SCHOOL & LOCATION
 Commodore John Barry Elementary School
 5900 Race Street, Philadelphia PA 19139
 PROJECT TITLE
 NEW CONSTRUCTION
 DRAWING TITLE
 SECOND FLOOR PLAN
 APPROVED BY

NO.	DATE	REVISION
1	1/17/07	ADDENDUM No. 1
2		
3		
4		
5		
6		
7		
8		
9

DRAWING NO.
P102

1 PLUMBING SECOND FLOOR PLAN
 1/8"=1'-0"

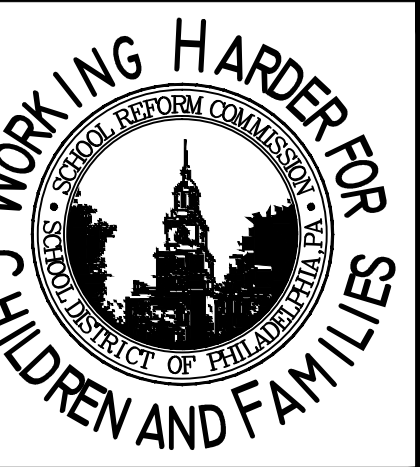
ALTERNATE NO. 4 -
 ADD TO FURNISH AND INSTALL SINKS AND ASSOCIATED PLUMBING IN CLASSROOM NOS. 205,206,207,208,209,210,211,212,213,214,215 AND 216 AS INDICATED ON PLUMBING PLANS. ADD WATER SUPPLY FROM WALL AND DRAIN LINES FROM FLOOR.
 BID PRICE FOR THIS ALTERNATE SHALL BE THE DIFFERENTIAL CHANGE IN THE BASE BID PRICE REPRESENTED FOR THE ALTERNATE NUMBER 4.
